RE: Planning Proposal – 20 Berry Street, North Sydney (DPIE Ref - PP-2021-2610)

ADDITIONAL OR REVISED DOCUMENTATION

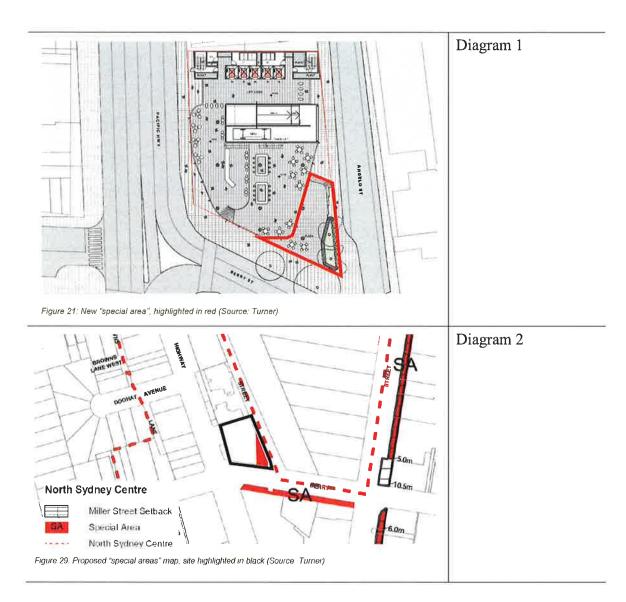
There is confusion as to what is proposed to constitute the extent of the proposed special area.

Figure 21 of the PP (refer to Diagram 1) indicates that the proposed Special Area is to wrap around the southern frontage to Berry Street, yet is shown as a smaller area on Figure 29 to the PP (refer to Diagram 2). These issues are replicated in the Urban Design Report prepared by Turner.

It is unclear as to what the numerical area of either of the identified special areas are. The PP merely states that an area of "more than 200sqm" will be provided.

The PP and Urban Design Report are to be amended to ensure a consistent extent of the Special Area and indicate what the numerical area is of the area to be identified as a Special Area.
